OSM/LUM DECISION SHEET (DSH)

Standard(s) (incl. year)	Subclause(s):	Tracking No.	Year
EN 60598-1:2015/A1:2018	4.11.3	DSH 0854A	2019
Category:			
LITE			
Subject:	Key words:	Developed by	Approved at
Screw connections	<ul style="list-style-type: none"> - Small “spikes” - Locking of screw connections - Fixing screws 	OSM/LUM-ETF5	2019 ETICS Plenary Meeting

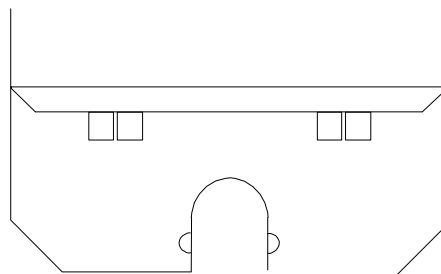
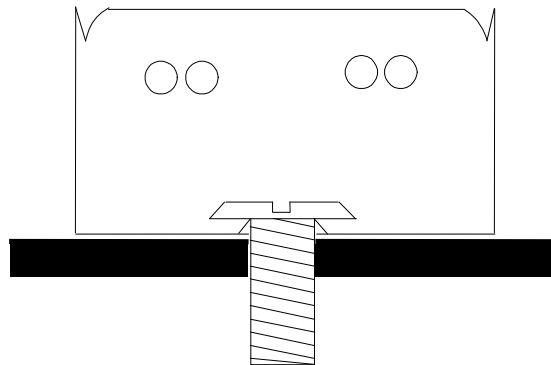
Are two small “spikes” for locking of screw connections of a ballast acceptable?

The solution is acceptable. Each case has to be judged on its own merits.
